APPEAL SUMMARY

Appeal ID: 27514	Project Address: 3231 SE 50th Ave
Hearing Date: 2/16/22	Appellant Name: Christopher Cardoza
Case No.: B-007	Appellant Phone: 503 9543065
Appeal Type: Building	Plans Examiner/Inspector: Chanel Horn
Project Type: commercial	Stories: 2 Occupancy: B Construction Type: V-B
Building/Business Name:	Fire Sprinklers: No
Appeal Involves: Alteration of an existing structure LUR or Permit Application No.: 21-115371-CO	
Plan Submitted Option: pdf [File 1]	Proposed use: Medical Clinic

Quest Center for Integrative Health
3231 SE 50th Ave., Portland, OR 97206
Project No. [21-019.1]

2 UPPER LEVEL OCCUPANCY/EGRESS PLAN
Scale: 1/8" = 1'-0"

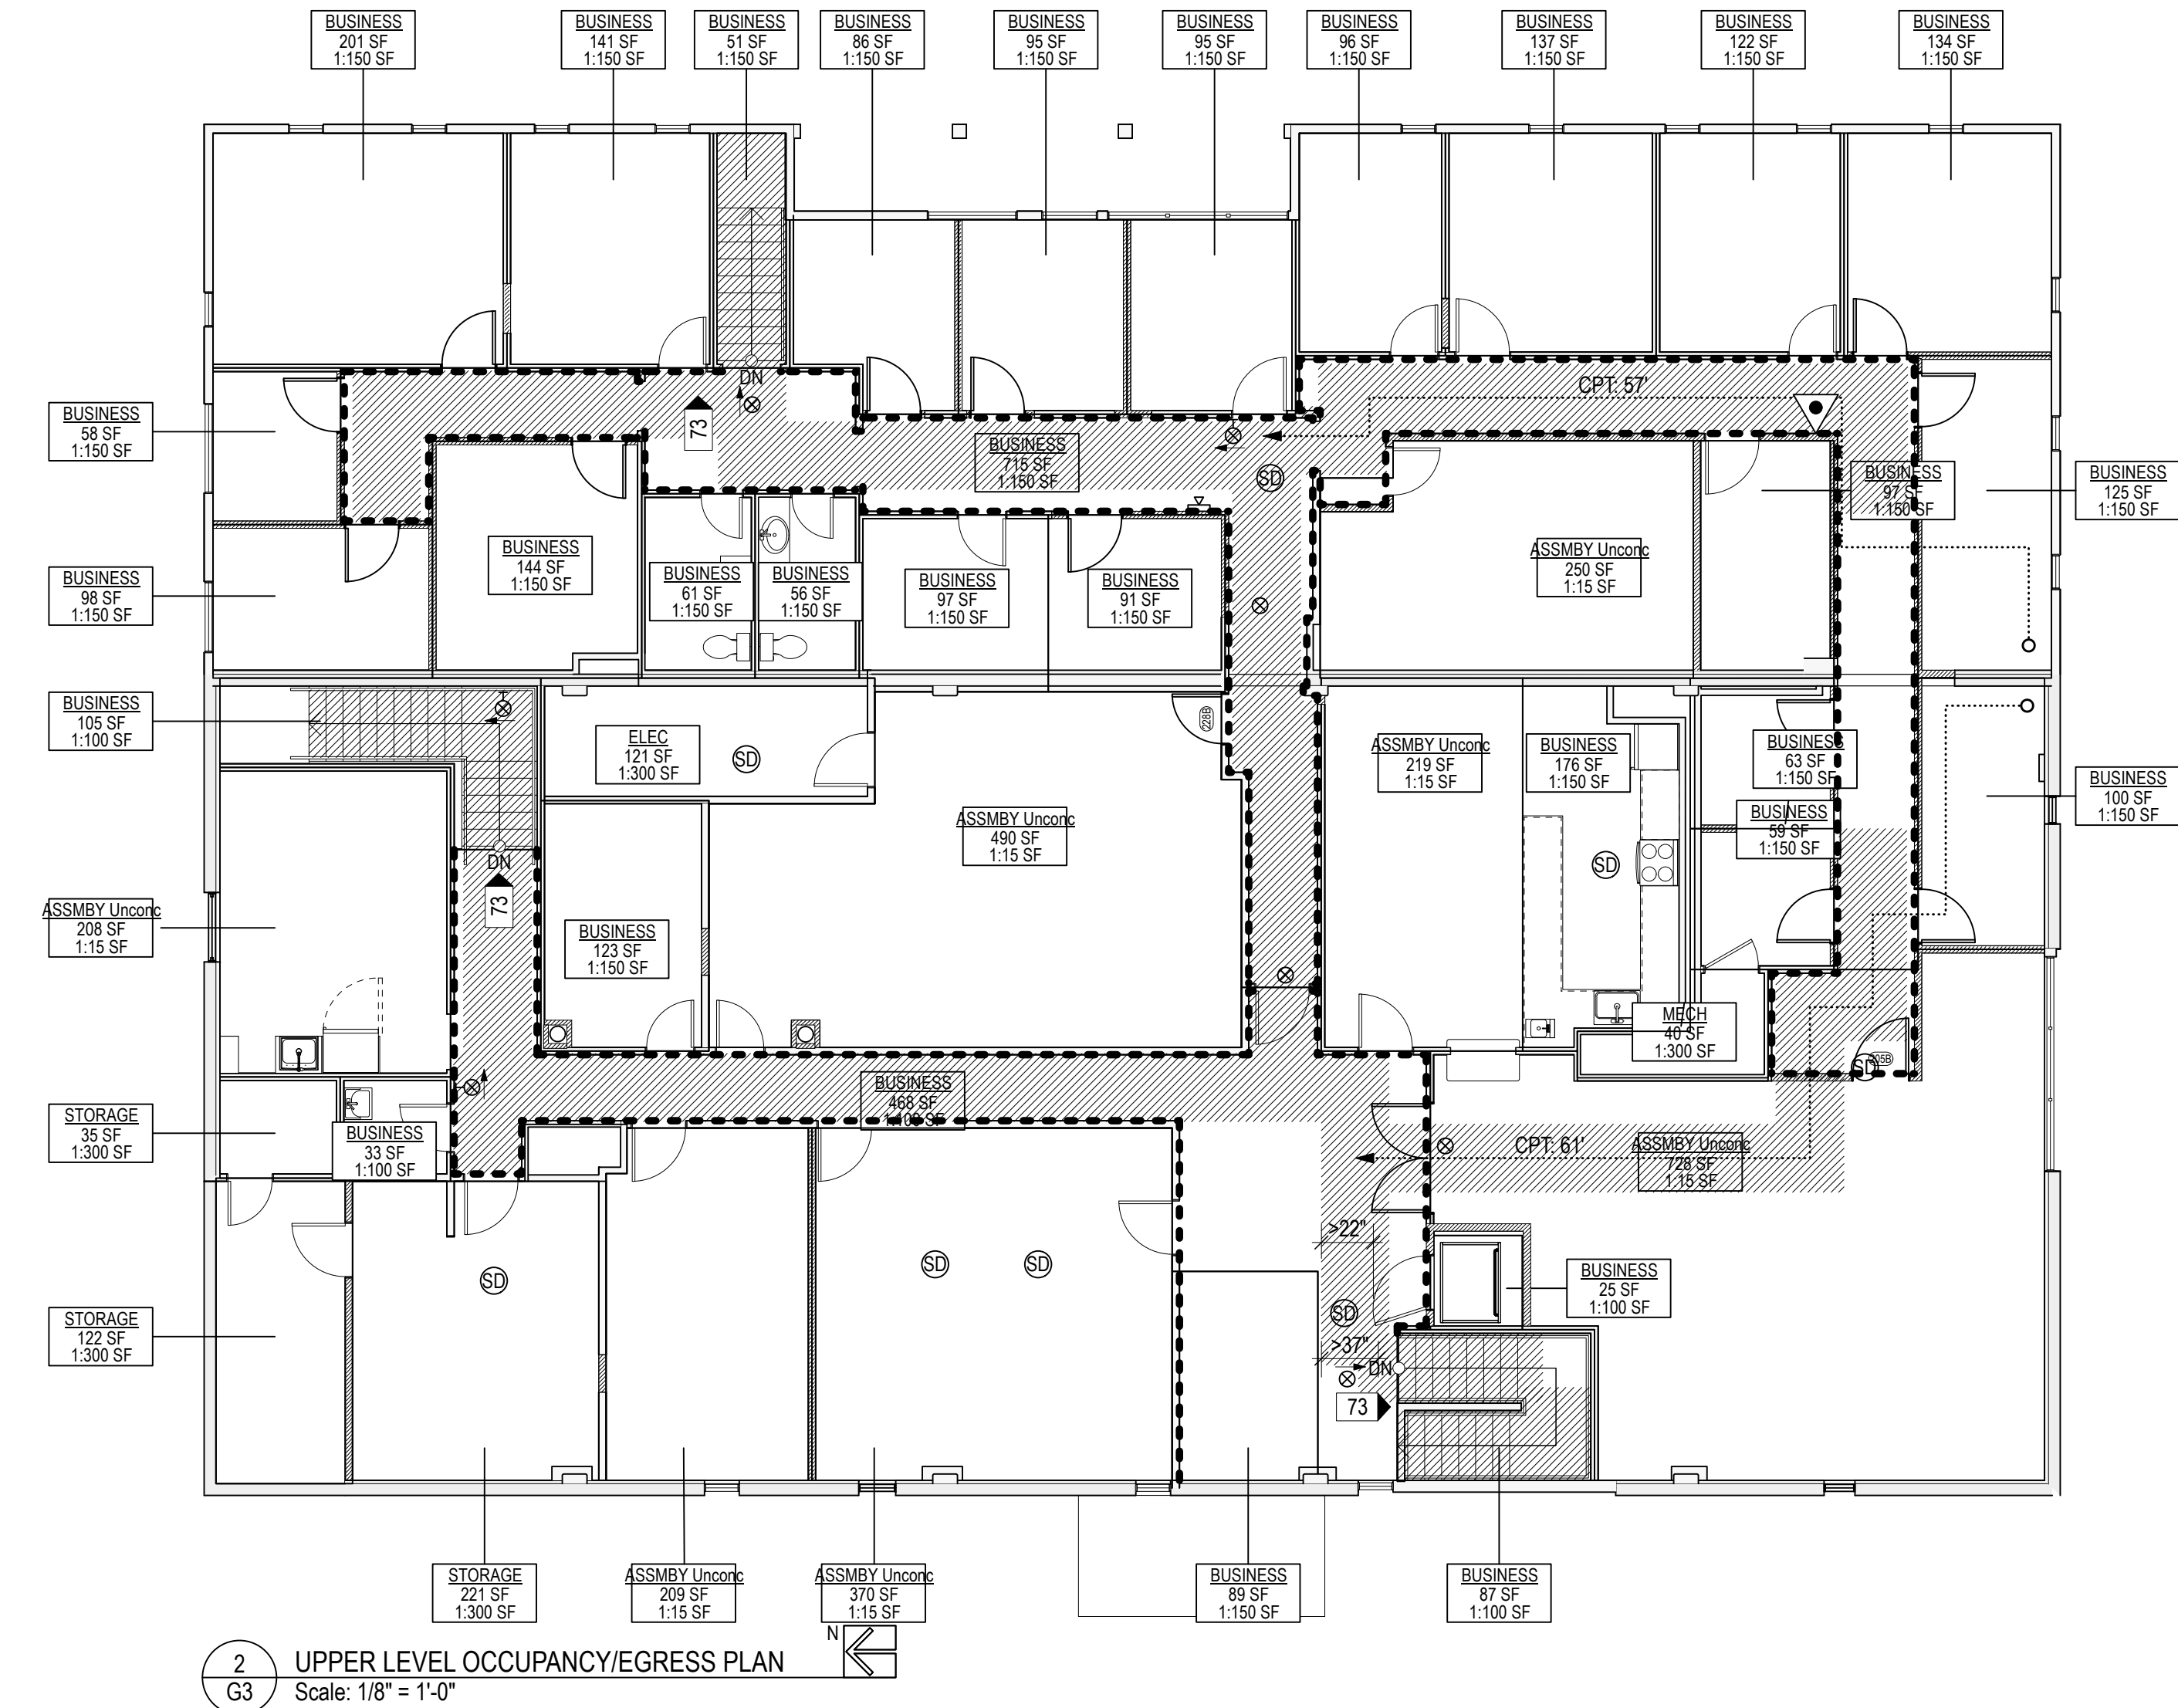
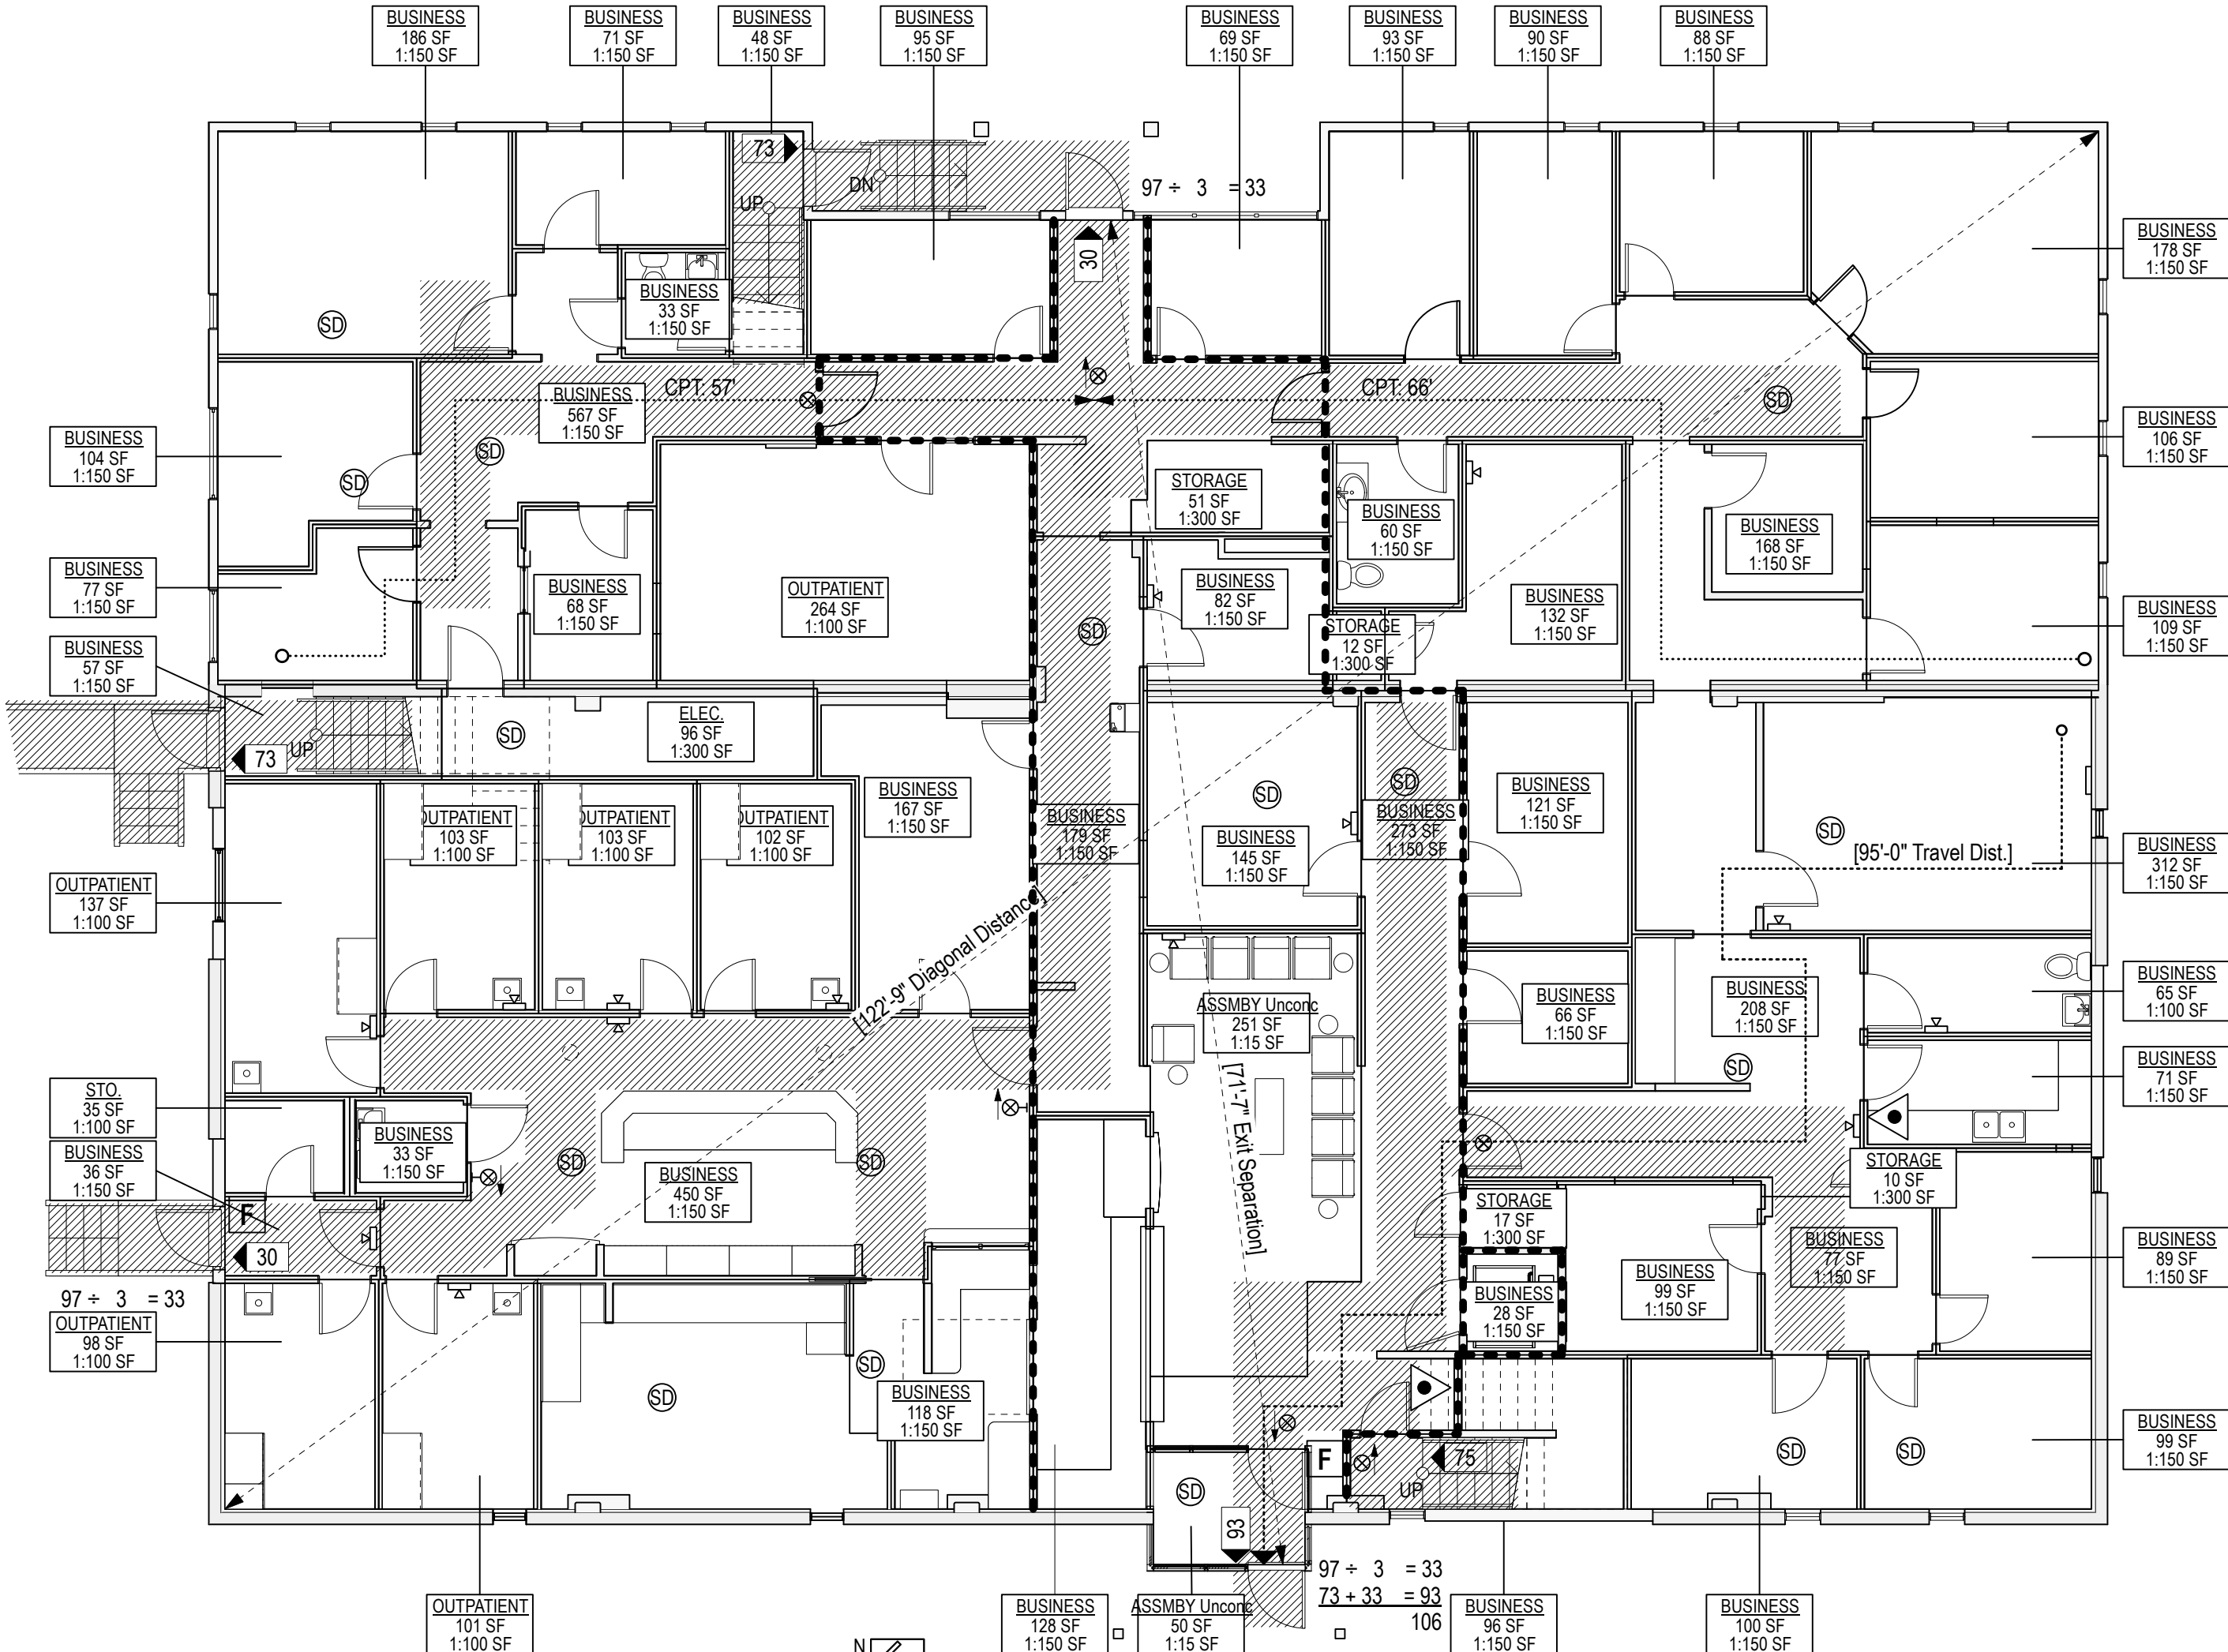
Proposed Design	<p>A reception area (area 201 on the second floor), off an exit corridor will be occupied by a receptionist and could be construed to be an intervening room. An early warning, ionization, fire detection system will be upgraded and maintained. It will automatically report to a central station. The walls of the area are of one hour construction.</p>
------------------------	---

Code Section	1020.2 (Table 1020.2)
Requires	The required capacity of corridors shall be determined as specified in section 1005.1, but the minimum width shall be not less than that specified in Table 1020.2.
Code Modification or Alternate Requested	To allow the existing condition of corridor 227A to maintain its location.
Proposed Design	The corridor at door 227A has a dimension of 44 ½" and meets code. Door 227B and the adjacent southern wall is marked for demolition to expand the corridor to a dimension of 50 ½". Corridor 237 between doors x228A and x203C is an existing condition and has a dimension of 42 ¾".
Reason for alternative	Corridor 237 is an existing condition, and we intend for it to remain as is. Existing and to remain are the three exits on this floor which is greater than the code required two. To provide the level of safety as described in the code we have opted to add door 228B to room 228 splitting its egress to avoid much of corridor 237. Additionally, door 227B and its adjacent walls are also removed to widen corridor 227 further increasing mobility through the building. We believe this provides the same level of safety as required by the code.

3. Location of reception area in a one hour fire rated corridor: Granted as proposed.

4. Decrease in the minimum allowable width of corridor 237 from 44 inches to 42 3/4 inches: Hold for additional information.
